Dean Moor Solar Farm

Applicant Response to ISH Action Points

25 November 2025
Prepared by: Stantec UK Ltd
PINS Ref: EN010155
Document Ref: D5.10
Deadline 5
Revision: 1

FVS Dean Moor Limited		
Title		
Issue Specific Hearing Action Point 31: Property Distances		
Scale 1:1,000 @ A3	Date: 21/11/2025	
Drawn: RP	Checked:	
Figure: 1	Sheet 1 of 1	Rev: B

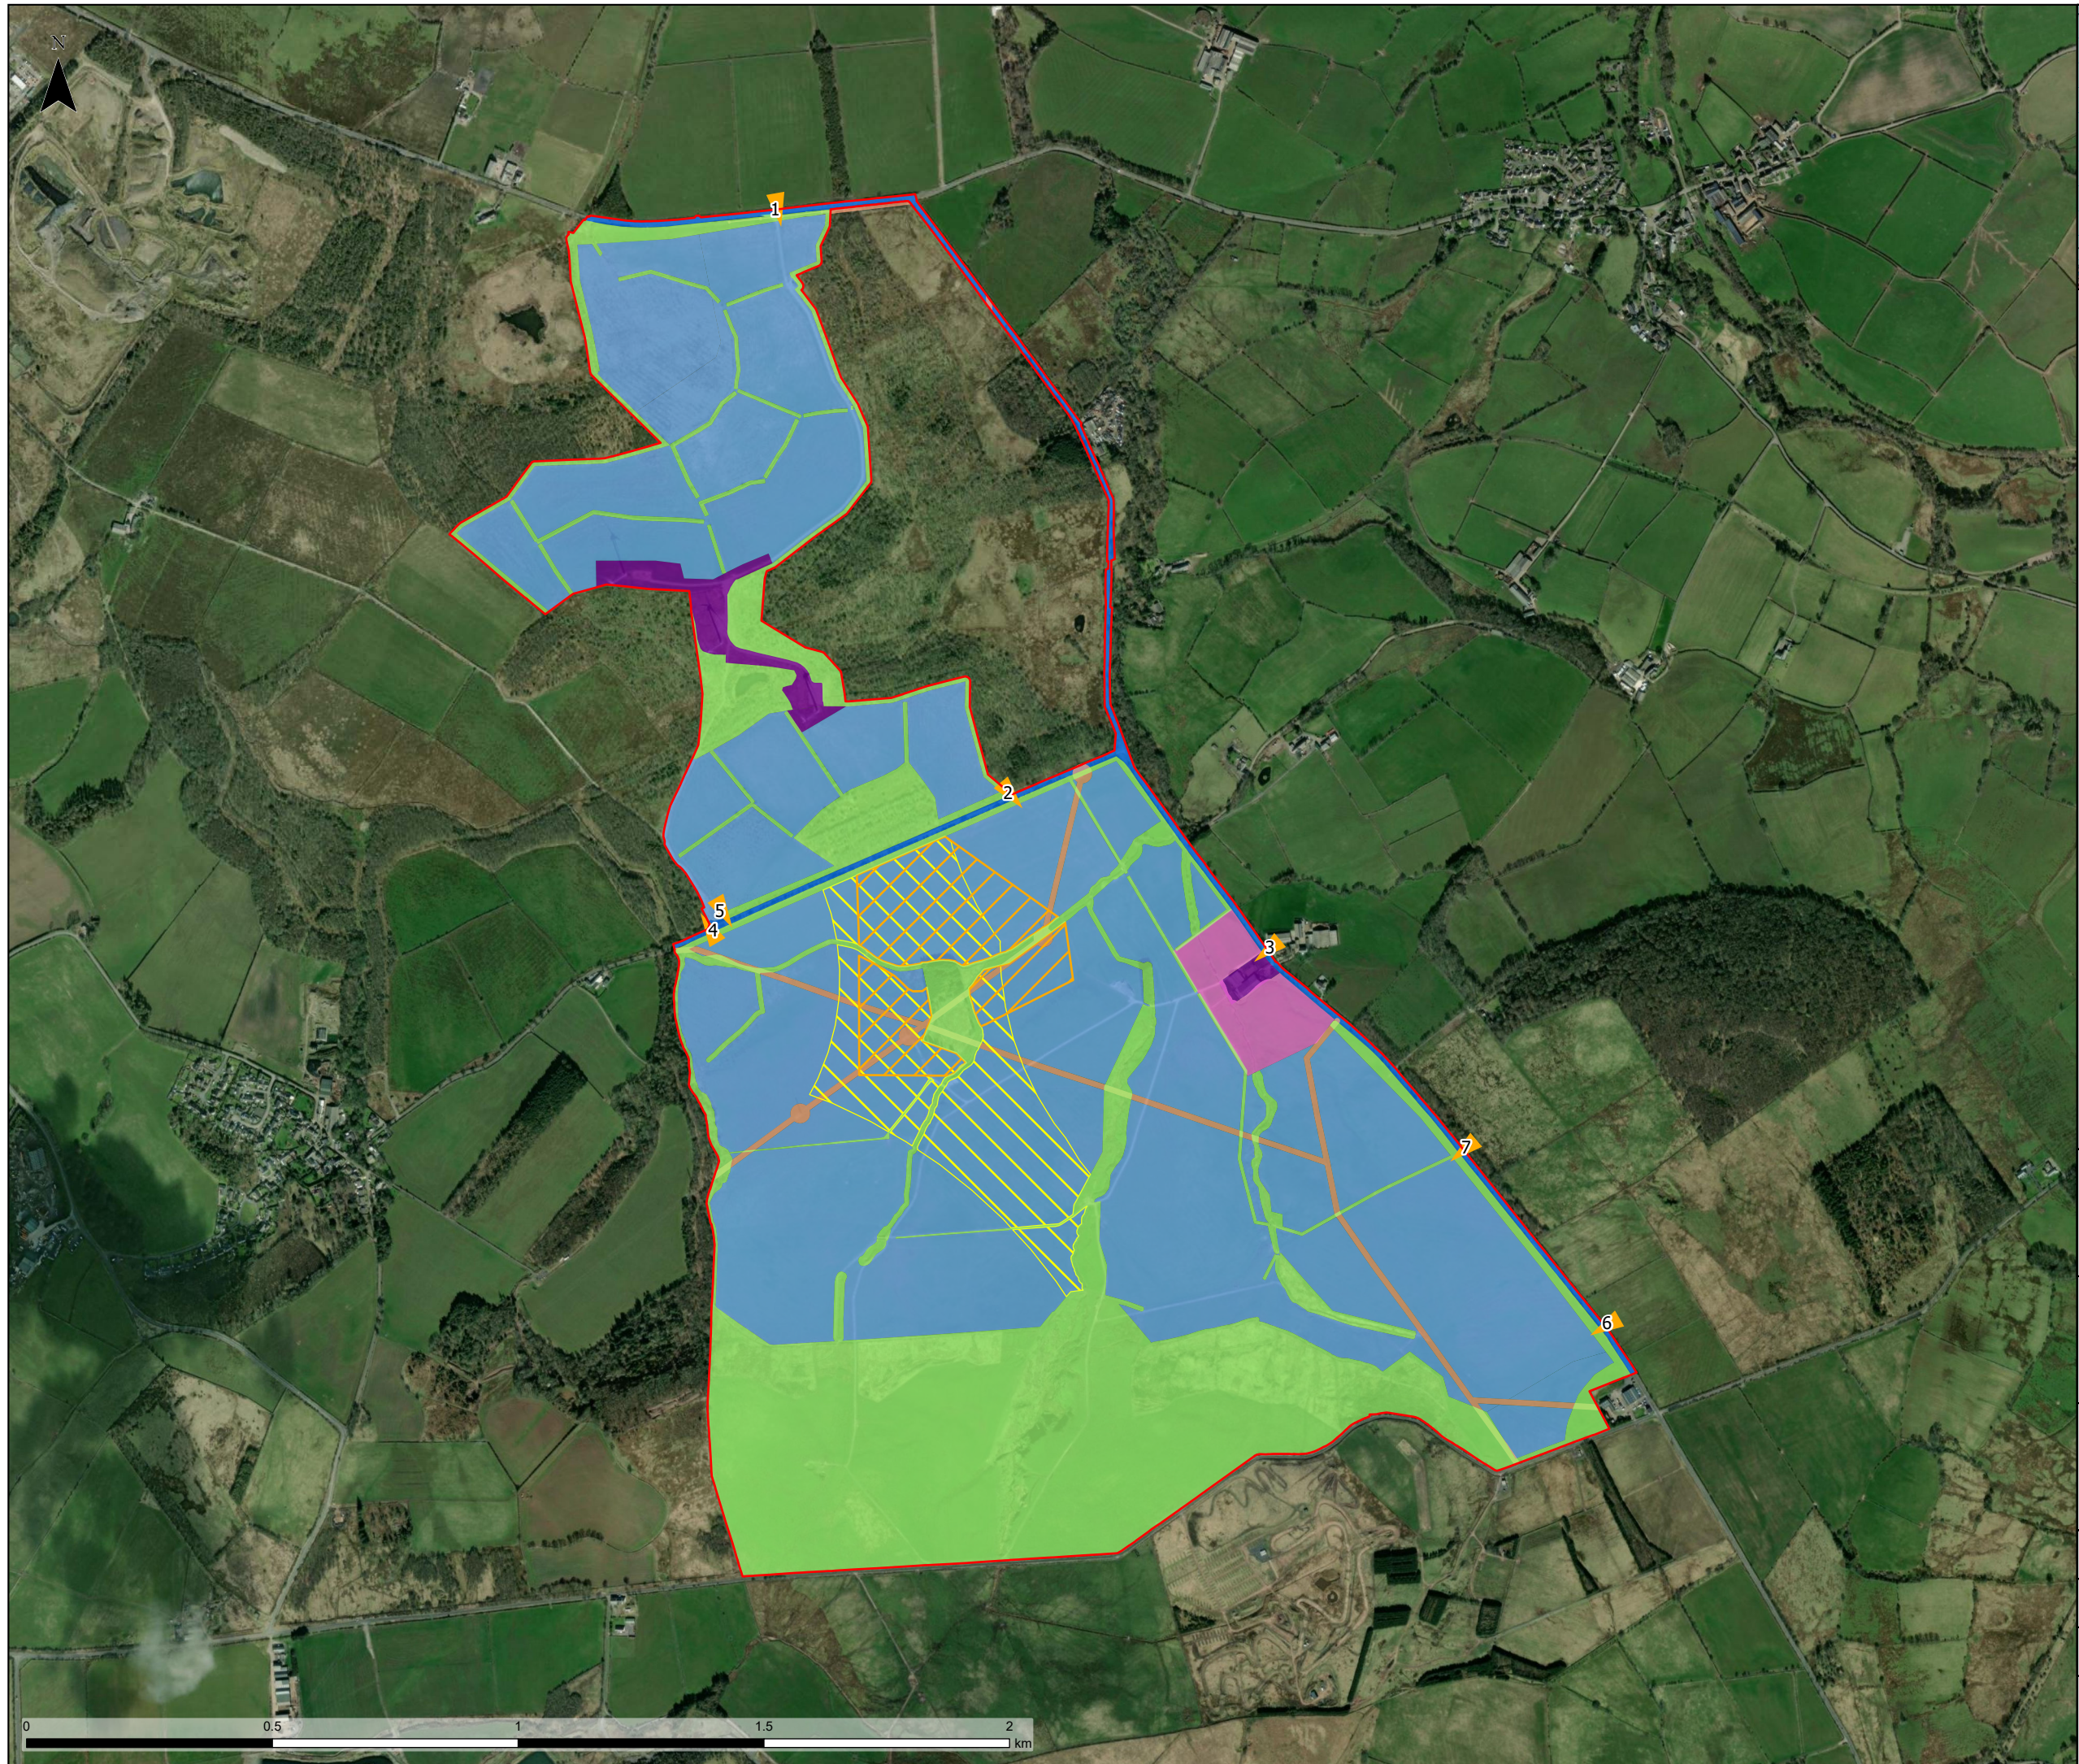
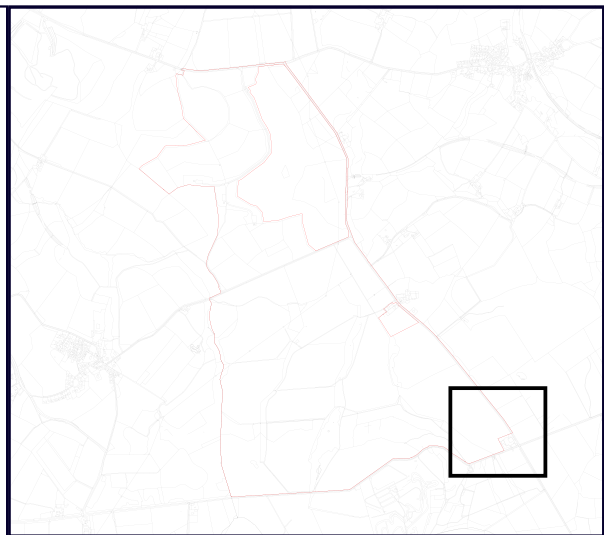
The Examining Authority (ExA) requested that the Applicant take it as an Action Point (AP) to provide further details (measurements) of the intervening distances between your property and the proposed solar PV arrays and landscaping.

The measurements requested are detailed within a table and figure which are provided below within this letter. Along with the measurements and figure we wanted to provide some insight into the distances selected and some context for them.

The distances provided are the distances to Work No.1 - Solar PV Infrastructure, and Work No.6 - Green Infrastructure (landscaping). The property is surrounded by Work No. 6, which has been included as a landscape buffer, and includes both grassland and structural landscape planting. Based on your comments at the ISH, it is the Applicant's impression that

To respond to this Action the Applicant considered the part of your property which is at the southeast corner of the Site bordered by Dean Cross Road to the south and Branthwaite Edge Road to the north, and by the Proposed Development Site west and north. This is an area of approximately 2.10 acres. The Applicant understands that your ownership extends into land south of Dean Cross Road and includes the motorcross park. This response focuses on the mixed commercial-residential plot bordered by the Site on two sides.

Distances are provided in Table 1 below and are best read alongside the corresponding figure which includes annotations so you know where the distances are to/from. You will note there is one set of distances which is provided only for the residential property, and this

For the landscaping to the west the Applicant notes there is a mature band of coniferous trees, but these have now grown to a height where there are lower level gaps. The Applicant has proposed transitional scrub and tree planting to taper from this to the hedgerow which will form a final arc of screening before Work No. 1. The Applicant has provided the distance from boundaries to the areas of scrub and hedgerow trees that are closest to the property. As the hedgerow forms the boundary of Work No.1, the distance to the hedgerow is approx. 1-2m less than the distance to Work No.1.
